**MATANUSKA-SUSITNA BOROUGH  
PLATTING BOARD  
AGENDA**

**FEBRUARY 4, 2016**

**STAFF REVIEW AND RECOMMENDATIONS  
PUBLIC HEARING  
FEBRUARY 4, 2016**

**PRELIMINARY PLAT: KINNEY RIDGE**

EXHIBIT F - /

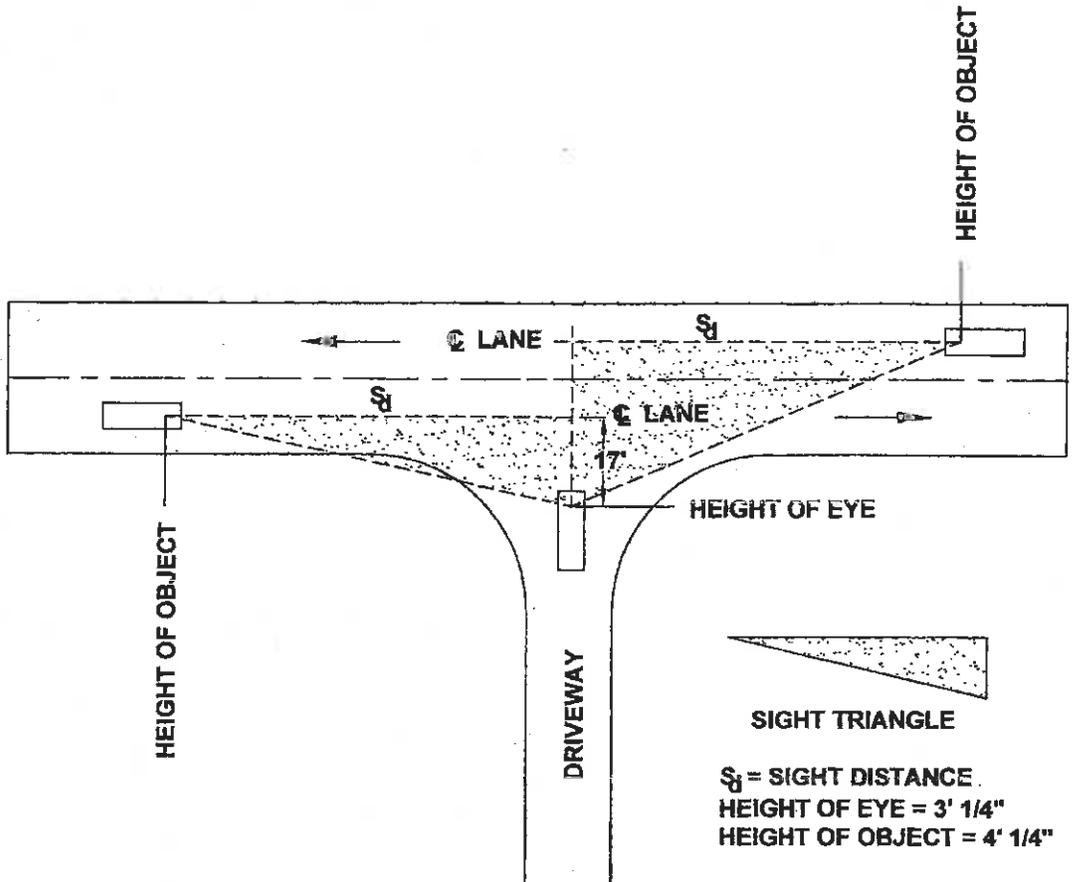
1. Existing driveway permit is issued to Jensen Road for this Lot. This driveway falls within proposed Lot 1A and is existing. Please provide the following plat note: "Driveway access to Tazlina Drive is prohibited from any lot.

2. All driveways must take access from the ROW of lowest classification that may bound a lot when bounded by one or more ROW's. Please provide the plat note: "Lot 1E shall be restricted to access to Showers Street." This driveway line of sight is restricted to the north around the corner and may need clearing on Lot 1D to make legal. Please provide for the clearing before disposal of the property so that proper line of sight can be obtained and a safe driveway can be installed on Lot 1E. A minimum line of sight distance can be determined from the attached line of sight drawing from the driveway guidelines that is based on the speed limit on Showers Street. Or, apply and install driveway access before subdivision recording.
